# 1993 Corvette: Service Bulletin: Transmission "Whine" Noise, Loss of Motion in all Gears, or Missing Clutch Disc Rivets

**Model and Year:** 1993 CHEVROLET CORVETTE WITH SIX-SPEED MANUAL TRANSMISSION AND 5.7L (LT1) ENGINE (VIN CODE P)

**Bulletin Number:** 37-71-40

**Casting Date**  
(located on right side of clutch  
housing, above part number)

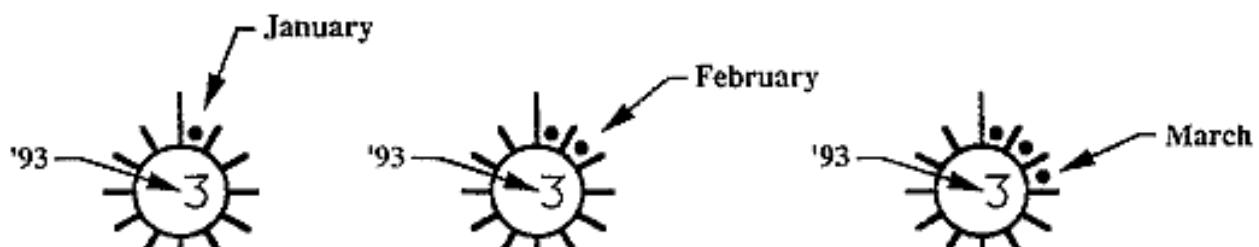
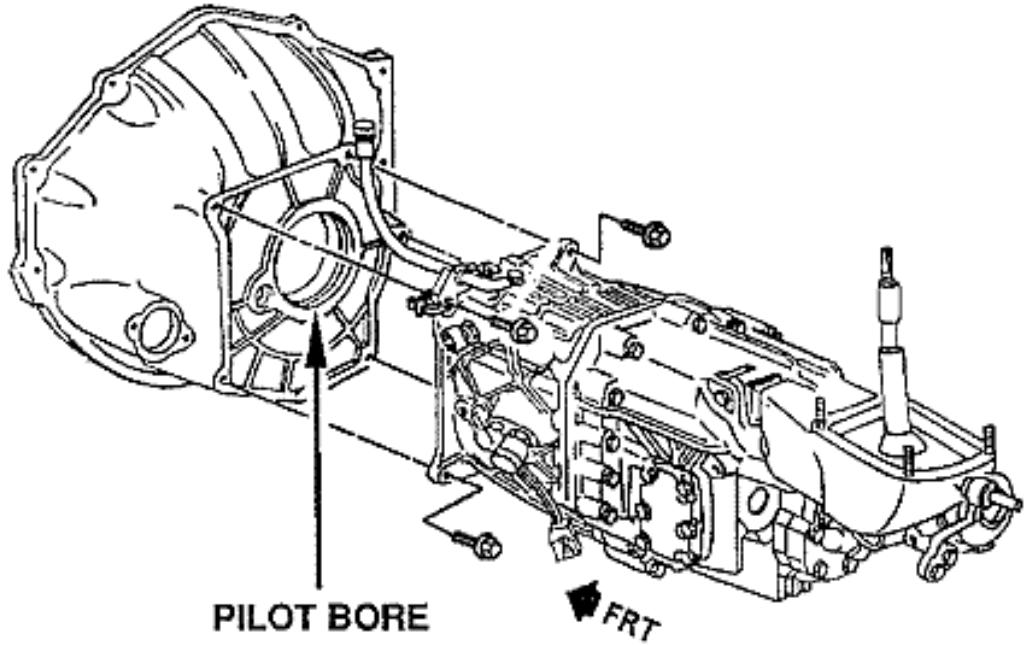
IF THE VEHICLE IS BUILT BETWEEN THE VIN BREAKPOINTS OF 110966 THROUGH 113902 AND THE CLUTCH HOUSING HAS A CASTING DATE OF EITHER "JANUARY, FEBRUARY, OR MARCH 1993", THE CLUTCH HOUSING MAY BE THE CAUSE OF THE CONCERNS. THE CLUTCH HOUSING MAY HAVE A MISLOCATED TRANSMISSION TO CLUTCH HOUSING PILOT BORE. SEE FIGURE.

THIS MISLOCATED PILOT BORE MAY SIDELOAD THE TRANSMISSION'S INPUT SHAFT, THEREBY PRODUCING THE "WHINE" NOISE.

VERIFY THE SUSPECT CLUTCH HOUSING HAS A CASTING DATE OF EITHER "JANUARY, FEBRUARY, OR MARCH 1993". NOTE: SUSPECT HOUSINGS WILL HAVE NO MORE THAN THREE (3) "DOTS" IN THE CAST DATE. SEE FIGURE.

AFTER ABOVE VERIFICATION, REPLACE CLUTCH HOUSING, P/N 10126448. PARTS ARE CURRENTLY AVAILABLE FROM GMSPO.
